ENGINEERS INSTRUCTION NO. E-03

From: Max Davis Reference: LCE14462 – 043a

Project Name: Hyde Park Place - 248 Unley Road, Hyde Park

Discipline: Electrical Services Date: 09/09/2020

Layout Apt 1.06

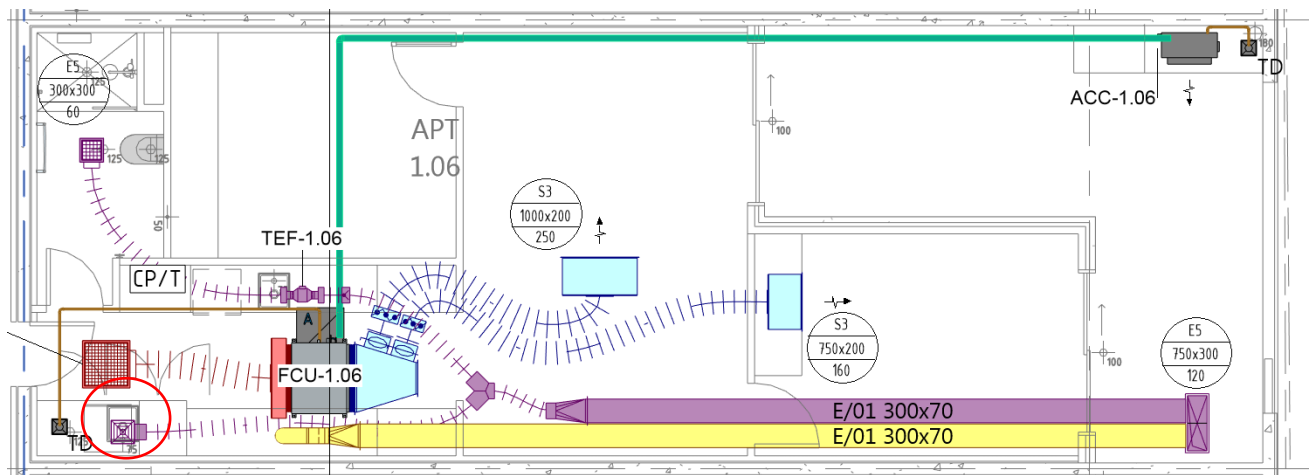
Locations of new header box fans are as per the following sketches (showing mechanical services layout):
